**PUD &
SUBDIVISION STAFF REPORT**

DEVELOPMENT NAME Long Street Bungalows

SUBDIVISION NAME Long Street Bungalows Subdivision

LOCATION West side of Long Street, 600' ± South of Old Shell Road.

SITE PLAN

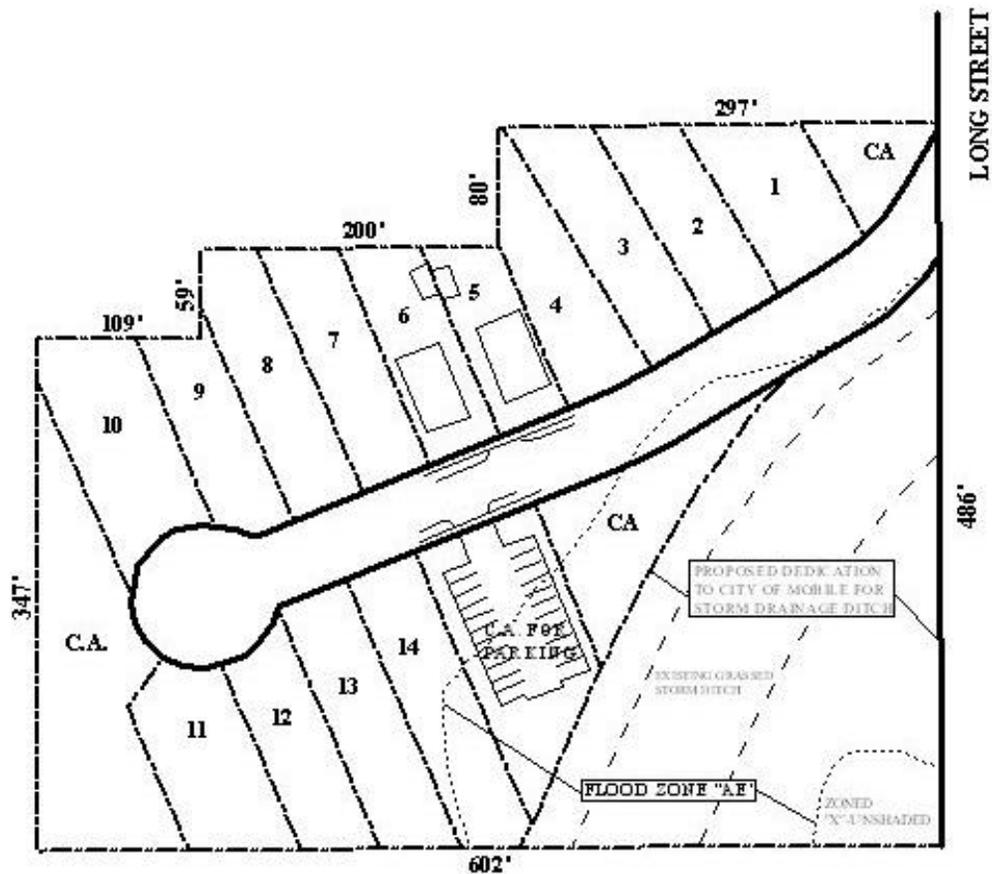
The plans indicate the dedication of the existing storm ditch, as well as additional property on each side, which appears sufficient to provide the easement requested by the Engineering Department.

Also shown on the plan are four common areas – one for storm water detention, two for resident use and the fourth a parking court for guest and overflow parking. To maintain the residential character of the development, it would be appropriate for this facility to be of an approved alternative parking surface.

RECOMMENDATION **Planned Unit Development:** based on the preceding, it is recommended that this application be approved subject to the following conditions: 1) exact road location and design to be coordinated with Urban Forestry, Planning and Engineering prior to issuance of any permits; 2) building setbacks to be coordinated with Urban Forestry and Planning prior to recording of the final plat; 3) parking area to be of an approved alternative parking surface; 4) construction of Long Street, from Old Shell Road to the proposed street, to a standard approved by City Engineering; 4) provision of sidewalks for the entire development, including the West side of Long Street; 5) dedication of the drainage right-of-way as shown on the plan submitted; 6) all common areas to be maintained by the property owners; 7) completion of the Subdivision process; and 8) full compliance with all municipal codes and ordinances.

Subdivision: based on the preceding, the plat is recommended for Tentative Approval subject to the following conditions: 1) exact road location and design to be coordinated with Urban Forestry, Planning and Engineering prior to issuance of any permits; 2) building setbacks to be coordinated with Urban Forestry and Planning, and reflected on the final plat; 3) construction of Long Street, from Old Shell Road to the proposed street, to a standard approved by City Engineering; 4) dedication and construction of the proposed street to city standards; 5) provision of sidewalks for the entire development, including the West side of Long Street; 6) dedication of the drainage right-of-way as shown on the plan submitted; and 7) placement of a note on the final plat stating that all common areas to be maintained by the property owners.
